Access Compliance Report

Public Rights-of-Way

(Curb Ramps)

Intersection ID: 8094	Main Street: KNOLLCREST_DR	Cross Street: S_RAMSEY_ST	Location:	N
ADA ID: B94F1418CDC7	Ramp Type: Perp	Initial Pass/Fail: Fail	Overall Compliance: No	Severity Score: 1.25

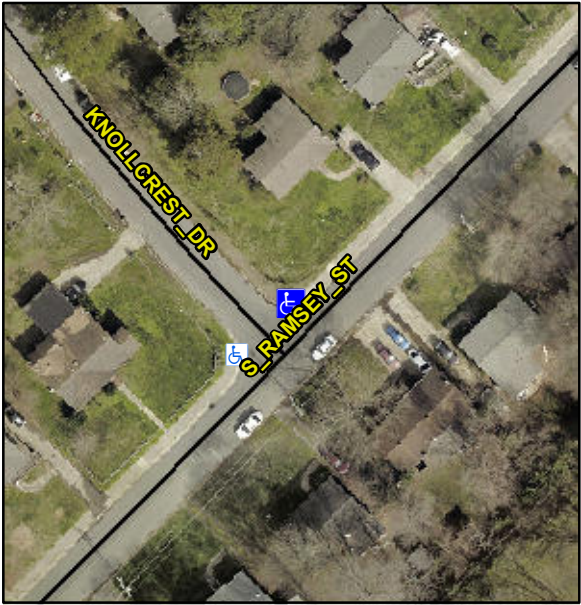
Codes/Mitigation Info/Possible Solution		Field Measurements/Component Compliance					
	Possible Solutions:	Compliance	Description	Data	Compliance	Description	Data
	Remove & Replace Entire Ramp.	N/A	Ramp Length (in)	24.0	Yes	Ramp Slope (%)	5.8
		Yes	Ramp Width (in)	48.0	No	Ramp XSlope (%)	3.6
		N/A	Flare Type LT	N/A	N/A	Flare Type RT	N/A
		N/A	Flare Slope LT (%)	N/A	N/A	Flare Slope RT (%)	N/A
		N/A	Flare Traversable LT?	N/A	N/A	Flare Traversable RT?	N/A
		N/A	Landing Length (in)	N/A	N/A	DWS Provided?	N/A
		N/A	Landing Width (in)	N/A	N/A	DWS Contrast?	N/A
		N/A	Landing Slope (%)	N/A	N/A	DWS Length (in)	N/A
		N/A	Landing X Slope (%)	N/A	N/A	DWS Full Width?	N/A
<p>Surveyor Notes:</p> <p>N/A</p> <p>PROW/ADA:</p> <p>Not Found, R304.5.3</p>		N/A	Landing Curb? (Y/N)	N/A	N/A	DWS Offset (in)	N/A
		N/A	Shared Landing?	N/A			
		N/A	Gutter Ponding?	N/A	N/A	Gutter Slope (%)	N/A
		N/A	Gutter Lip Ht (in)	N/A	N/A	Gutter X Slope (%)	N/A

N/A	Painted X Walk1?	No	N/A	Painted X Walk2?	N/A
			X Walk 1 Direction	To SW		X Walk 2 Direction	N/A
		N/A	X Walk 1 Width (in)	N/A	N/A	X Walk 2 Width (in)	N/A
			X Walk 1 Slope (%)	0.0		X Walk 2 Slope (%)	N/A
			X Walk 1 X Slope (%)	5.0		X Walk 2 X Slope (%)	N/A
		N/A	Ramp inside XWalk1?	N/A	N/A	Ramp inside XWalk2?	N/A
<p>Total Cost:</p> <p>\$ 1850.00</p>			Road Slope (%)	N/A	N/A	Clear Space?	N/A
			Road X Slope (%)	N/A	N/A	Clear Space to XWalk (in)	N/A
		N/A	Any Obstructions?	N/A	N/A	Storm Grate/Utility Hazard?	N/A
			Obstruction Type			Storm Grate/Utility Type	
				N/A			N/A
					Yes	Surface Condition? (G/P)	Good
